SHEARON HARRIS NUCLEAR POWER PLANT
DOCKET NO. 50-400/LICENSE NO. NPF-63
EMERGENCY ACTION LEVEL REVISION 01-1

HNP EAL Rev 01-1 Change Comparison and 10 CFR 50.54(q) Effectiveness Review Summary

Change Comparison for EAL Flowpath terminus (no event condition identified), Side 2

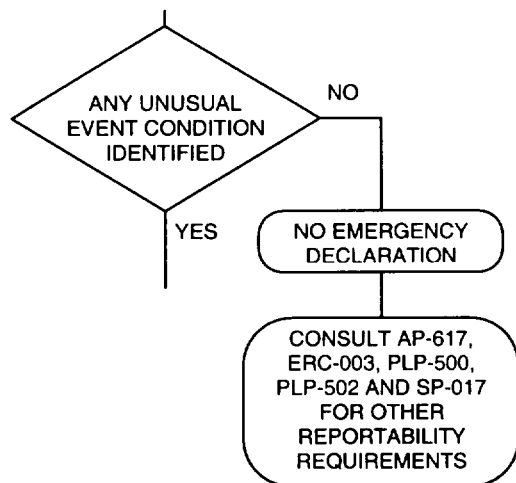
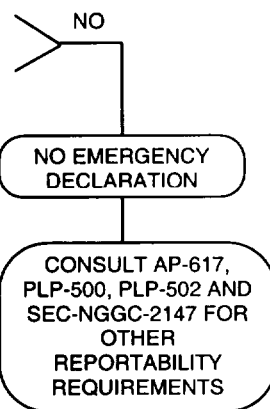
*Deleted ERC-003 and
replaced SP-017 with
SEC-NGGC-2147*
